Docket No. 50-336

The Commission has issued the enclosed Amendment No. 61 to Facility Operating License No. DPR-65 for Millstone Nuclear Power Station, Unit No. 2. This amendment consists of changes to the Technical Specifications in response to your applications dated August 10, 1979 and May 9, August 29 and September 30, 1980, as supplemented on numerous other dates.

This amendment authorizes Cycle 4 operation at 2700 Mwt with:

FIGURE 2.1-1 Reactor Core Thermal Margin Safety Limit - Four Reactor Coolant Pumps Operating

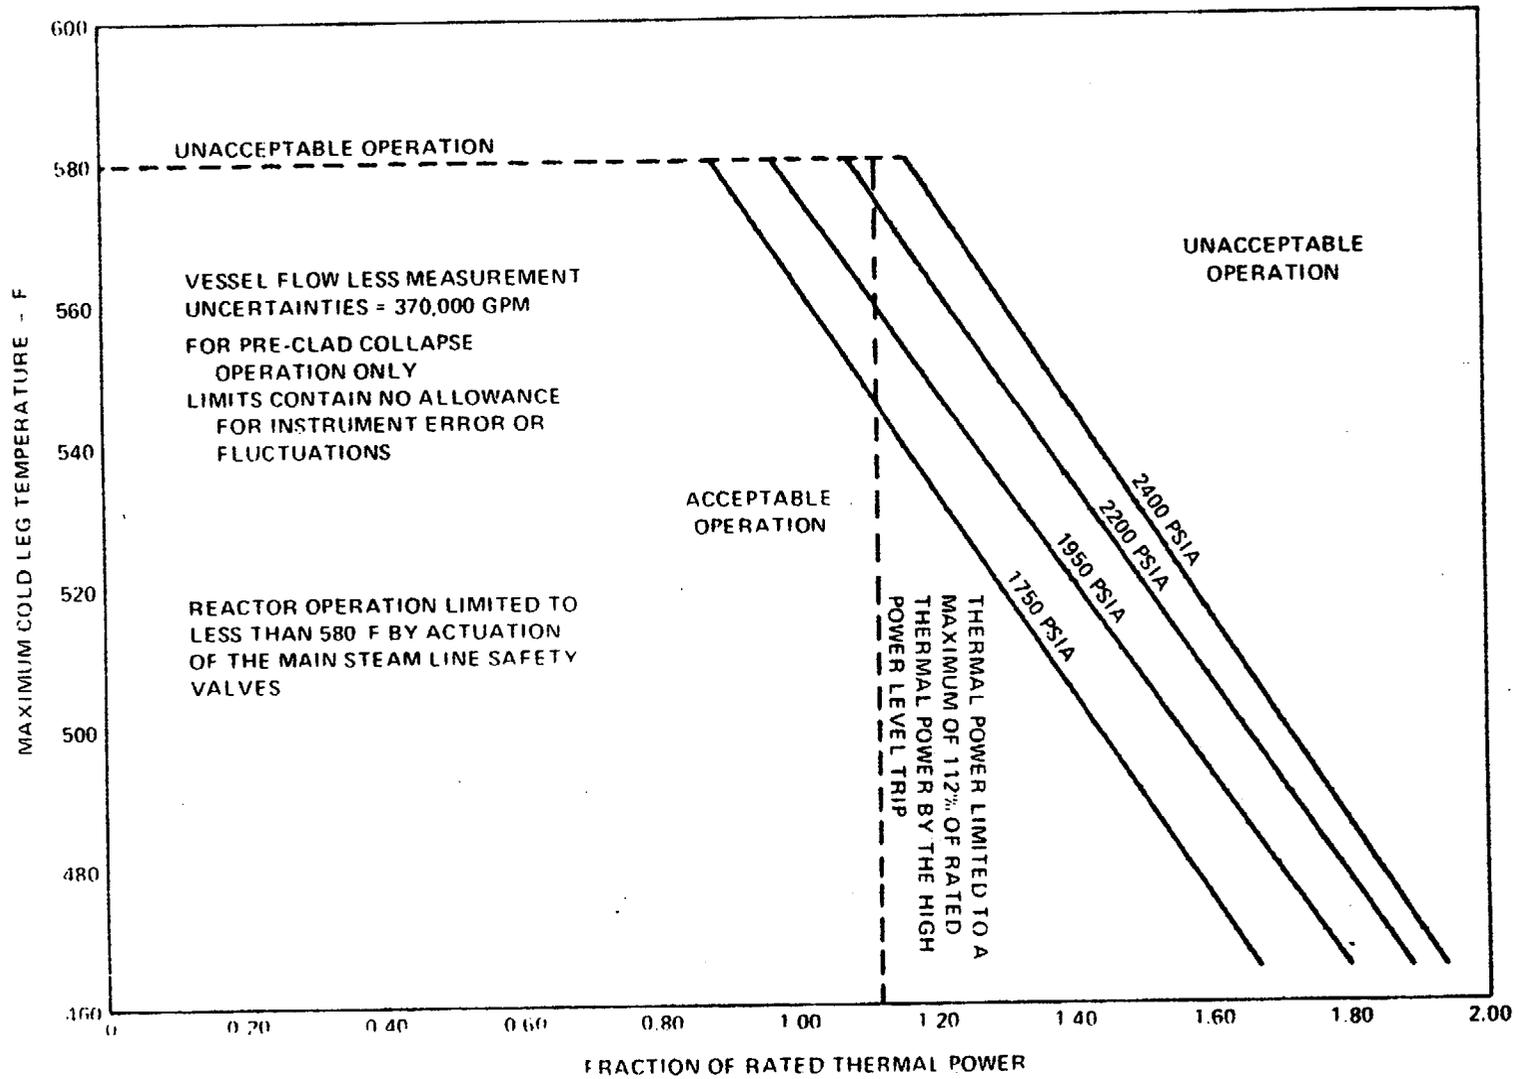
In the CE analysis for Cycle 3, a curve of axial power distribution values was used for the thermal margin safety limits. However, for the W Cycle 4 analysis, the axial power distribution methodology is utilized directly to produce the local power density-high trip setpoint. Therefore, TS Figure B2.1-1 is no longer required. We find this methodology acceptable.

FIGURE 4.2-1 Augmentation Factors vs Distance From Bottom of Core

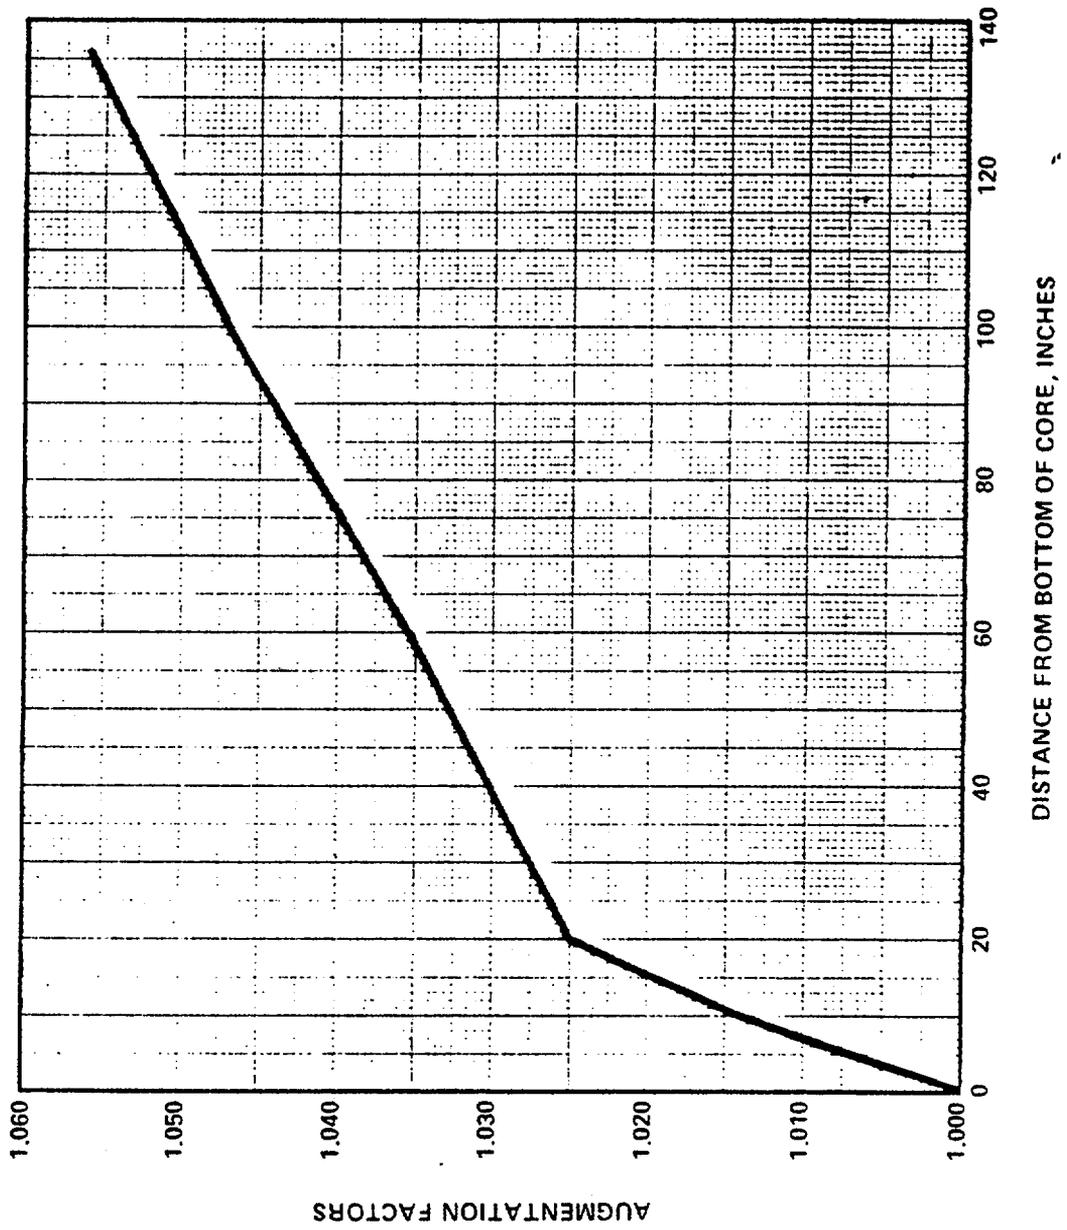
TS Figure 4.2-1 (page 3/4 2-5) will need revision to reflect the augmentation factor which applies to the W Batch F fuel. The proposed augmentation factors bound the CE fuel remaining in Cycle 4. We find this new curve acceptable.
